Office of General Services

ADDENDUM NO. 5 TO PROJECT NO. 45382

**HAZARDOUS, CONSTRUCTION, HVAC, PLUMBING, AND ELECTRICAL WORK
RENOVATE BUILDING 8, 8TH & 9TH FLOOR
STATE OFFICE BUILDING CAMPUS
1220 WASHINGTON AVE.
ALBANY, NY**

November 1, 2024

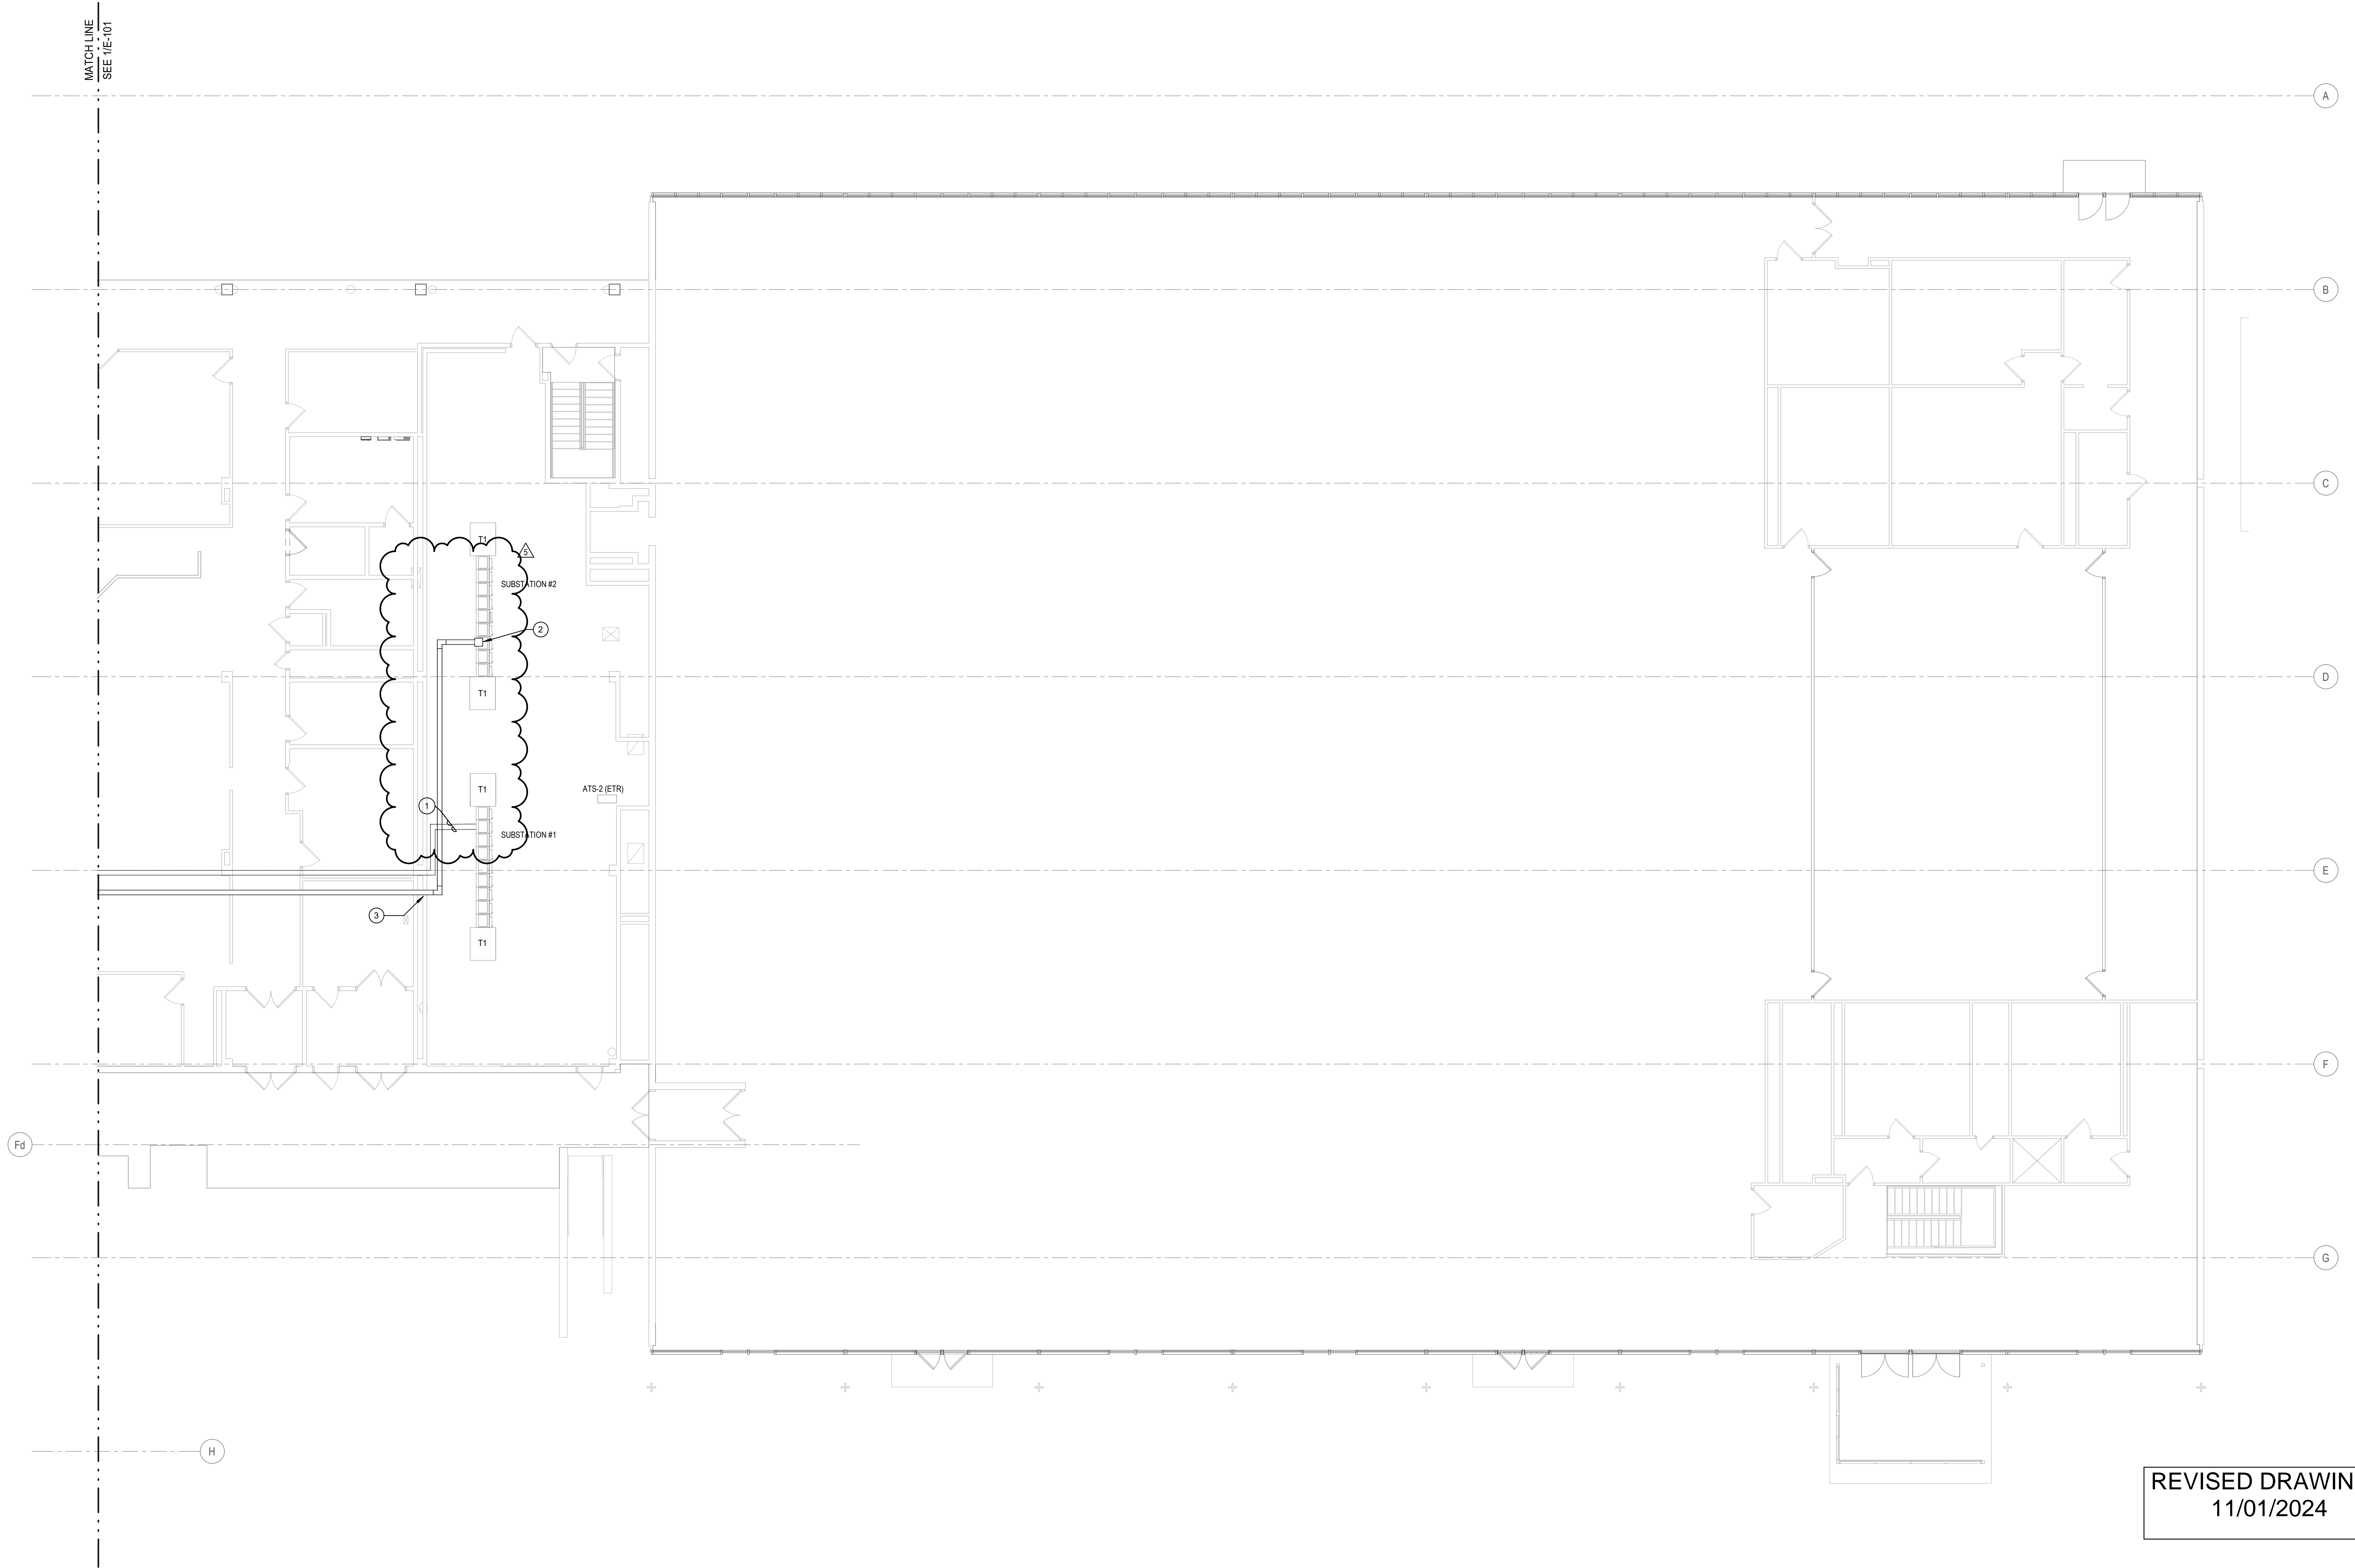
8. Drawing No. ED-601:
 - a. Delete Coded Removal Note 1. and replace with the following: “1. DE-ENERGZIE, DISCONNECT AND REMOVE FEEDER FROM SUBSTATION TO POWER PANELS 8-5-C-HV, 8-6-C-HV, 8-7-C-HV, 8-8-C-HV, 8-9-C-HV AND REPLACE. FEEDER SIZE SHALL MATCH EXISTING. PANELS ARE LOCATED BETWEEN COLUMNS 6F AND STAKED ON RESPECTIVE FLOORS WITHIN IDENTICAL CLOSET. WORK SHALL BE COMPLETED ON WEEKENDS WITH PANELS ON THE 5TH AND 6TH FLOORS NEEDING TO BE OPERATIONAL BY 6 AM THE NEXT WORKING DAY.

- b. Delete Coded Removal Note 9. and replace with the following: “9. EXISTING GE INTELLIGUARD BREAKER CURRENTLY LABELED AS GTB-2, HOWEVER THE BREAKER IS NOT BEING USED. CHANGE OVERCURRENT PLUG FROM 100A TO 800A AND USE BREAKER TO FEED 800A BUS DUCT TO PANEL PH-HV-3 IN PENTHOUSE.

- c. Delete Coded Removal Note 10. and replace with the following: “10. DISCONNECT AND REMOVE EXISTING 200’ OF 3” CONDUIT WITH 3 SETS OF (3) 350 KCMIL AND (1) #2G.”

- c. Delete Coded Removal Note 11. and replace with the following: “11. EXISTING OPEN SWITCH VERIFY FRAME SIZE AND TRIP RATING. REPLACE WITH GE INTELLIGUARD TYPE BREAKER WITH 1600AMP FRAME AND 800A AND USE BREAKER TO POWER FIRE PUMP CONTROLLER.
9. Revised Drawings:
- a. Drawing No. E-101A, E-110, E-602, E-607, noted “REVISED DRAWING 11/1/24” accompanies this Addendum and supersedes the same numbered originally issued drawing.
